**Punch List for South Texas Project Units 3 & 4
Sections 3.7 & 3.8**

**South Texas Project Units 3 & 4
Clarifications from NRC**

Issue 8: [Received 04/04/2011] (Audit Action Item 3.7-33 and 35) Stability Analysis Procedure

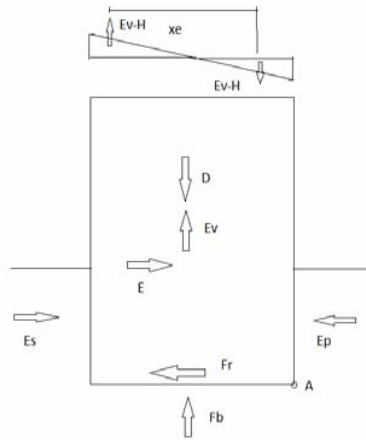
A brief presentation of the stability analysis procedure was made by the applicant during the March 14, 2011 audit. The presentation included a rigid body diagram showing the forces acting on the structure for stability calculations. The applicant indicated that the total seismic demand is calculated by summing all the inertia forces and moments acting on the structure. These inertia forces are calculated by multiplying the mass of each node by the absolute value of the maximum acceleration response at that node obtained from the SSI analysis.

The calculation of the seismic overturning moment is based on the horizontal seismic load E and vertical seismic load E_v about tipping point A, as shown in the figure below. The moment due to horizontal earthquake does not include E_v-H (vertical force due to horizontal input) which also produces overturning moment about A. The applicant is requested to provide justification for not including the vertical component of response due to horizontal seismic input in calculating the foundation overturning moment.
